Sandpoint Reference Platform Errata

Board Revision Level	X2
Errata Revision Level	G

Table 1: Summary of Sandpoint Errata

Errata 7: Target System Reset

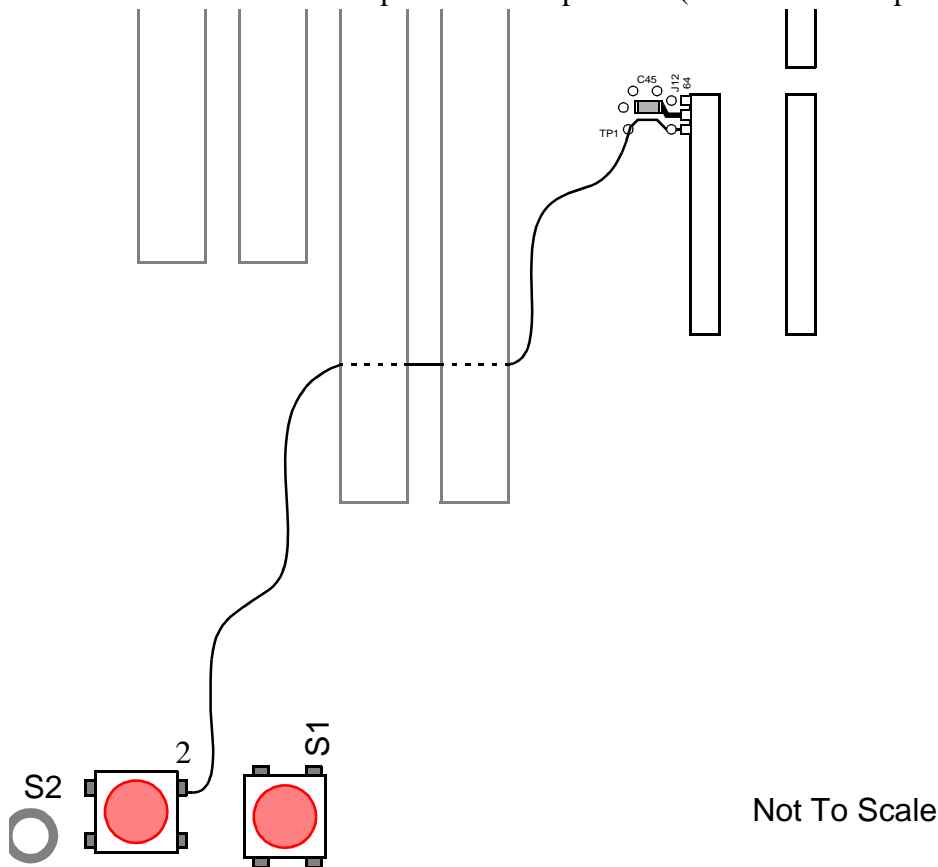
COP in-circuit emulators may not be able to reliably gain control of the target system if the reset command issued to the PPMC card does not also reset the motherboard (Sandpoint). The cause is apparently due to interrupting a PCI transaction the Winbond before completion. If the Winbond is not reset, the system will lock up until a global reset is issued.

The latest VITA specification has added a pin to the PPMC connector for just such a purpose. The rework adds this function.

The work-around is to connect the new SYSRST* function to the reset switch pin.

1. Connect a wire to pin 2 of S2 to pad TP1 (connects to J12 pin 60).
